*THE NATIONAL BOARD
OF BOILER AND PRESSURE VESSEL INSPECTORS*

NATIONAL BOARD INSPECTION CODE GRAPHITE TASK GROUP

MINUTES

Meeting of March 26th, 2024
Columbus, OH

FIGURE S3.5.6

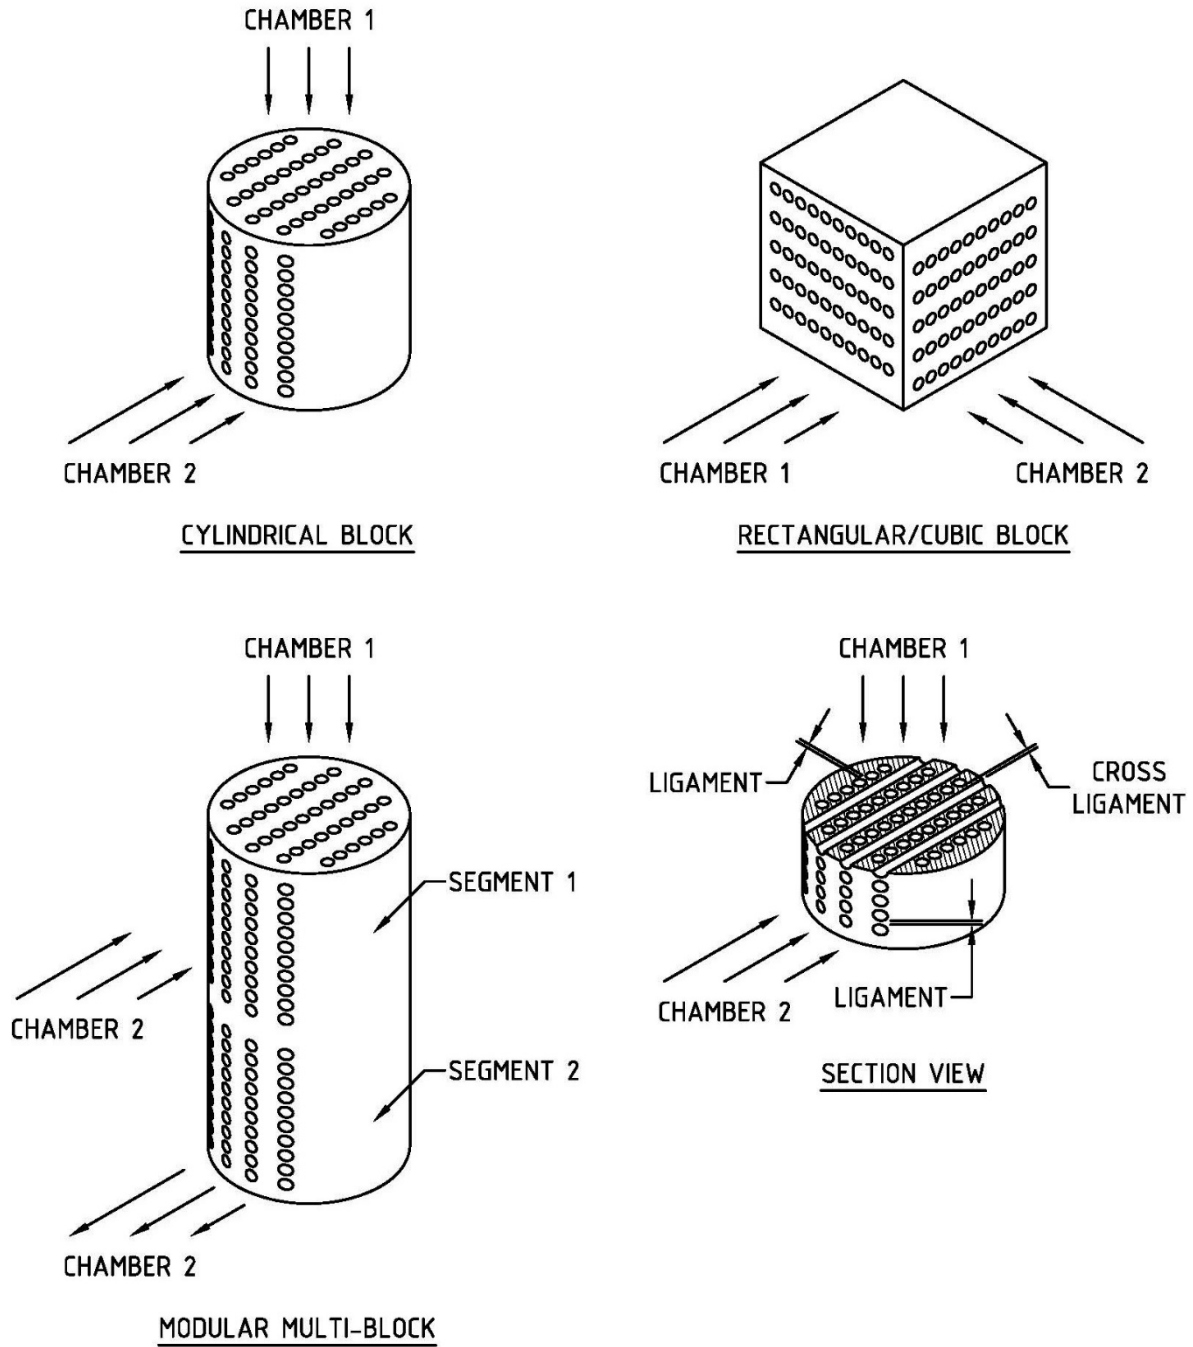
- a) Cross-drilled blocks ~~may~~ can experience failure in a cross ligament, due to ~~a~~ cracks or erosion, that leads to fluid transfer between the opposing chambers. The general steps used to repair a cross-drilled block that is transferring fluid follow below.

- 1) Isolate one chamber sufficiently to perform a pressure test.
 - 2) Test the isolated chamber.
 - 3) Check the opposing chamber for affected holes.
 - 4) Identify and mark any leaking holes.

- 5) Plug all leaking holes per S3.5.4.
- b) During visual inspection of a cross-drilled block, same chamber ligament cracking can may be identified. To prevent crack propagation, the affected area can be repaired by material inlaying, or the affected holes can be plugged per S3.5.4

FIGURE S3.5.6-d

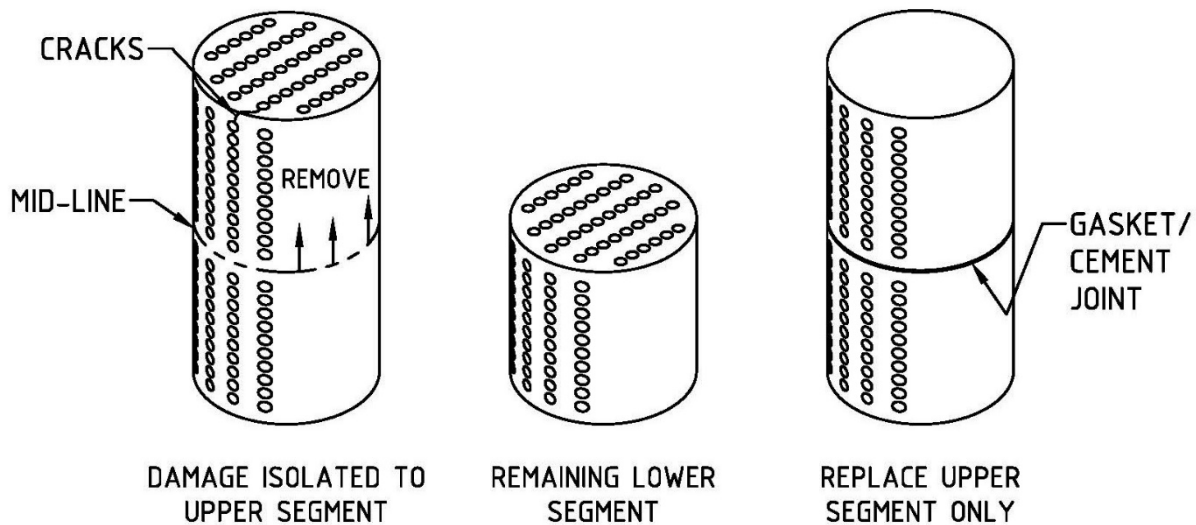
- ~~e)e) When a modular multi-block type of cross-drilled block is confirmed to be transferring fluid, is showing visible ligament cracking, or has visible surface erosion damage, it shall be tested as required according into S3.5.6-a. Once the location of all the damage is identified, if a single Ssegment is determined to be free of damage, that segment may be re-used after cutting away the damaged affected segment(s). The portion of the block that was removed shall be replaced.~~
